Access Compliance Report Public Rights-of-Way (Curb Ramps)

Main Street: MARTHA_ANN_DR Cross Street: SILVERWOOD_DR Location: N

ADA ID: RPAT211201105229 Ramp Type: Type 1 - Perpendicular Initial Pass/Fail: Pass Overall Compliance: No Severity Score: 9

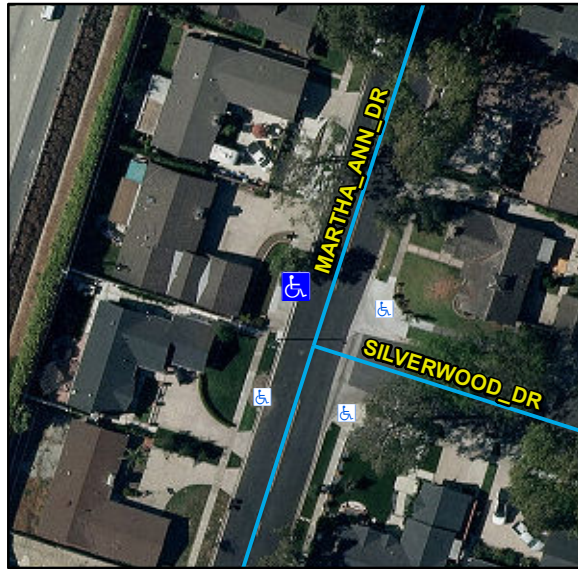
R304.2.2, R304.2.1, R304.5.4, STD 1115

N/A	Ramp Inside Crosswalk 1	N/A	Yes	Ramp Inside Crosswalk 2	N/A
	Crossing 1 Slope (%)	0.8		Crossing 2 Slope (%)	N/A
	Crossing 1 Cross Slope (%)	6.3		Crossing 2 Cross Slope (%)	N/A
Yes	Gutter Ponding	No	No	Curb Slope	5.8
Yes	Gutter Lip Height (in)	0		Road Run Slope (%)	N/A
No	Gutter Run Slope (%)	5.8		Road Cross Slope (%)	N/A
Yes	Gutter Cross Slope (%)	0.2			
Yes	Overall Surface Condition: Acceptable		Yes	Perp Joint Present	Yes
	Cross Gutter Present?	No		Spandrel Present?	No
	Replace Cross Gutter?	N/A		Replace Spandrel?	N/A

Remove & Replace Entire Ramp. Remove & Replace Gutter.
